**Proposal for a new UN Regulation on the approval of devices
for reversing motion and motor vehicles with regard to the
driver's awareness of vulnerable road users behind vehicles**

**Submitted by the Informal Working Group on Awareness of
Vulnerable Road Users Proximity***

OICA Comment: Green

Japan Comment: Purple

Utilization of tractor-units as solo vehicles

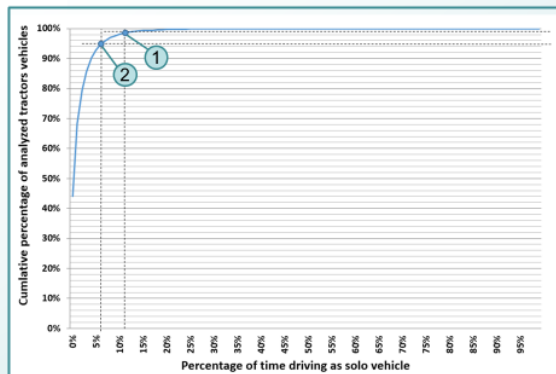
- Vehicles intended to be used with a semi-trailer shall be exempted from this Regulation.

OICA Justification: already discussed in the previous IWG meeting with CP

- 99% of tractor units are driving 11% or less of the driving time as solo vehicle ①
- 95% of tractor units are driving 6% or less of the driving time as solo vehicle ②
- 75% of tractor units are driving almost never (less than 0.2%) as solo vehicle

- Very low occurrence of tractor-units driving solo
- OICA proposal to exempt tractor units from the reversing motion legislation

Understanding of some definitions used in the regulation

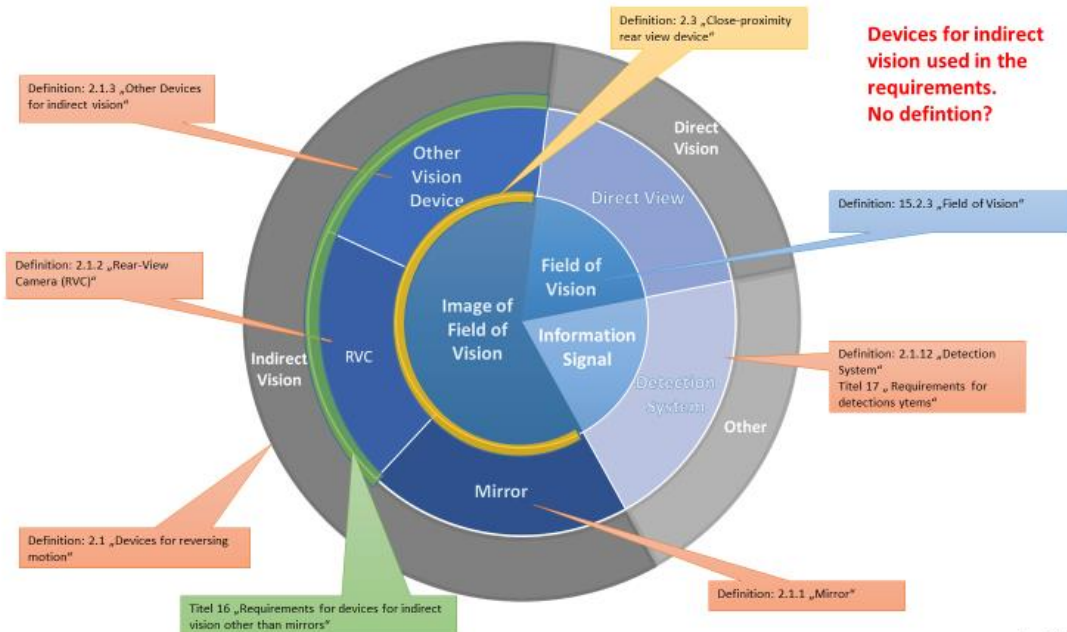
Comment: Do we all have the same understanding of the definitions?

- Devices for reversing motion:
 - o Include Indirect vision + direct vision + Other (grey ring)
 - If yes, we shall modify the definition
 - If no, what is a device for reversing motion?
 - o Include Indirect vision only?
 - If yes, it is equivalent to the definition “close proximity rear view device”

- We propose to replace Camera-Monitor System (CMS) by Rear-View Camera (RVC) to avoid misunderstanding between UN-R46 and this regulation

Japan Comment: It is Indirect Vision only.

Japan Comment: Agreed. All description of CMS was replaced to RVC.

Japan Comment: This figure is matching intention of devices for this regulation.

Figure 2

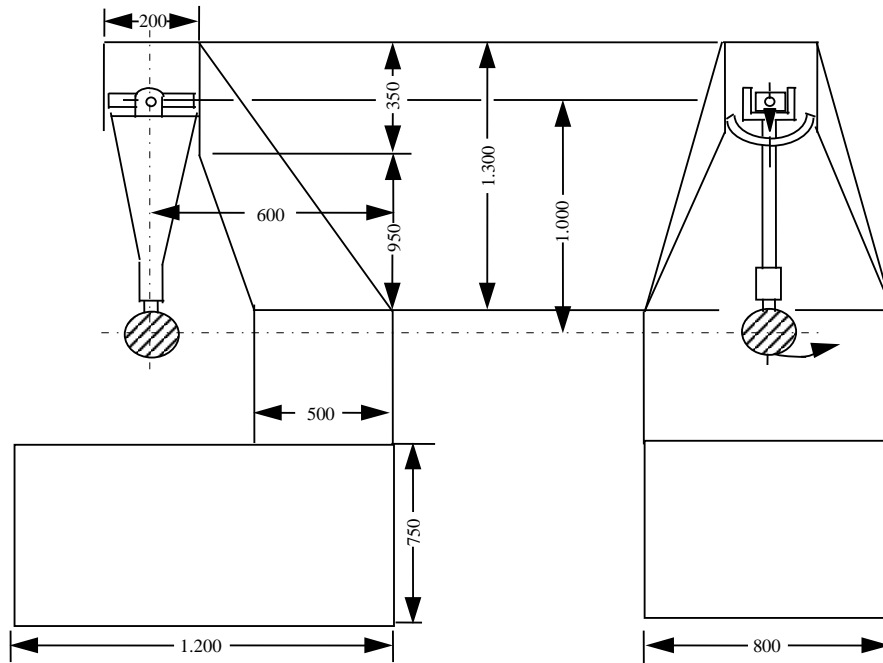
OICA Comment: The complete section 6.3 is not clear. What needs to be tested? Outside component, inside component?

Japan Comment: To make it clear, 6.3.1 corrected.

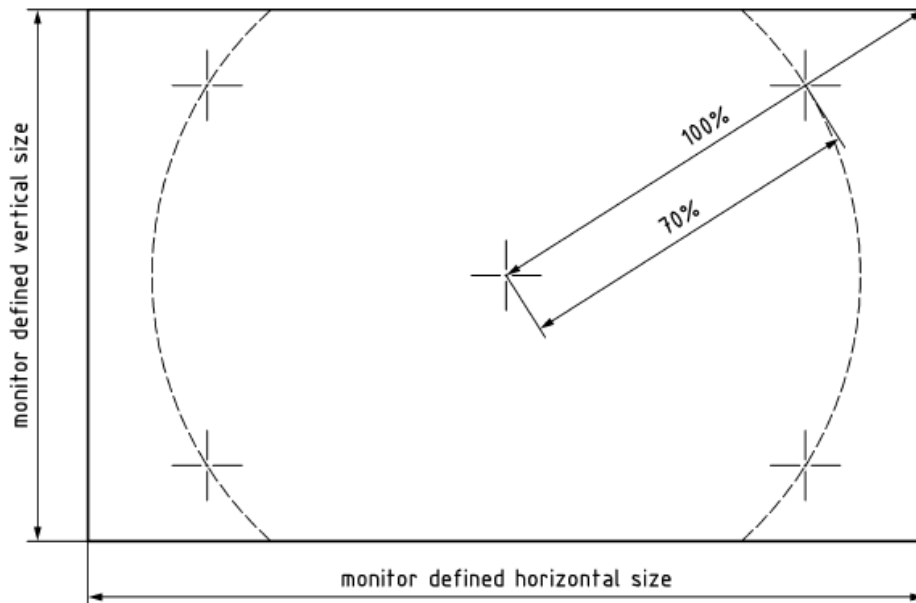
~~The resolution (MTF) defines the minimum distinguishable details observable in an image as is represented by the MTF10. For reasons of simplicity the requirement is defined assuming an aspect ratio of 1:1.~~

~~Resolution MTF10, at the centre of the monitor defined size shall fulfil the following requirements:~~

Japan Comment: To be removed, not fit rear-view camera that have fish-eye lens.
